**DEPARTMENT OF TRANSPORTATION****National Highway Traffic Safety Administration****49 CFR Part 572****[Docket No. NHTSA-01-11111]****RIN 2127-AH02****Anthropomorphic Test Devices; 3-Year-Old Child Crash Test Dummy**

**ACTION:** Final rule; response to petitions for reconsideration.

Figure P4

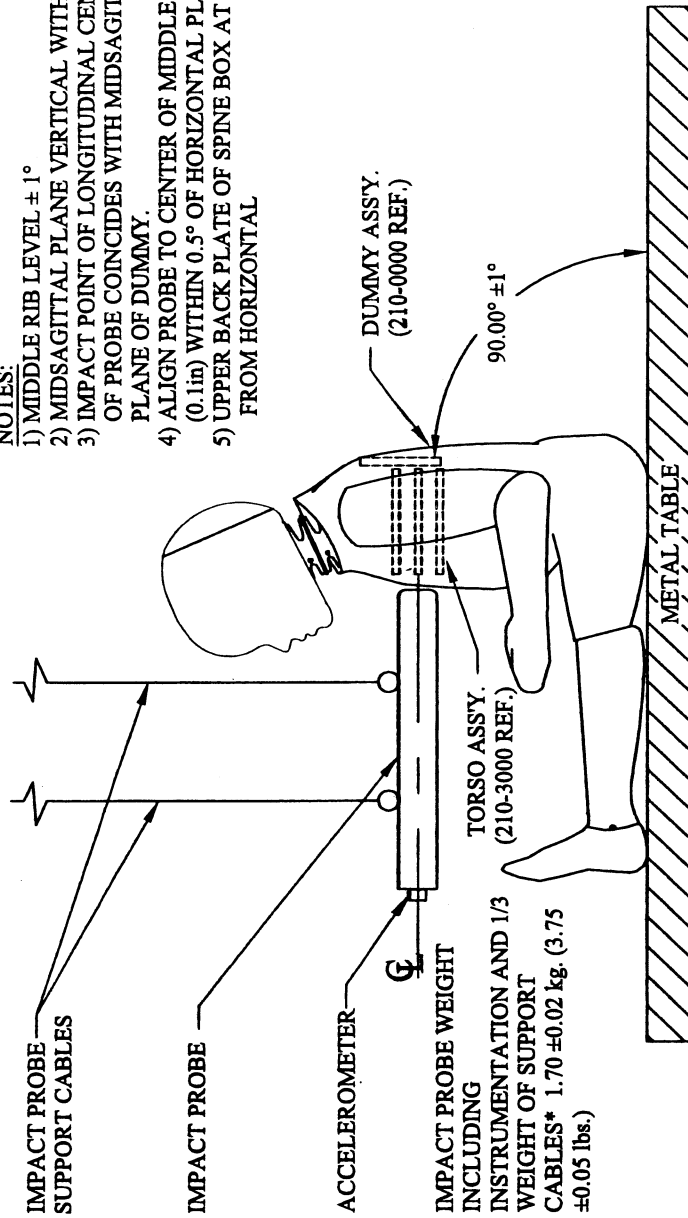
*Mass (Weight) Distribution:* Section 572.146(a) also specified that the test probe shall have a mass of  $1.70 \pm .01$  [kilograms] kg ( $3.75 \pm 0.02$  (pounds)(lb)). The Alliance and FTSS believed that a weight tolerance of 10 grams is too small to be practically measured. The Alliance requested that the tolerance be increased to  $\pm 0.02$  kg ( $\pm 0.05$  lb). FTSS recommended  $\pm 0.023$  kg.

*NHTSA's Response:* NHTSA agrees that the tolerance of  $\pm 0.02$  lb might be difficult to achieve because some of the accelerometers used on the crash test equipment weigh as much as 0.02 lb while others are as low as 0.002 lb. The agency believes that the total impactor weight tolerance should, to the extent possible, take into account the weight differences between many possible types of accelerometers used on impactors. Accordingly, we agree with the Alliance recommendation to increase the overall weight tolerance to  $\pm 0.02$  kg ( $\pm 0.05$  lb), which allows less than 3 percent variation in the overall weight of the impactor. The weight specification is also changed in Figure P4 of Part 572, Subpart P, titled "Thorax Impact Test Set-Up Specifications."

4. In § 572.146, revise paragraph (a), add paragraph (l)(2)(iv), and revise Figure P4 to read as follows:

\* 1/3 WEIGHT OF PROBE SUPPORT CABLES AND THEIR ATTACHMENTS TO THE IMPACT PROBE NOT TO EXCEED 5% OF THE TOTAL IMPACT PROBE WEIGHT.
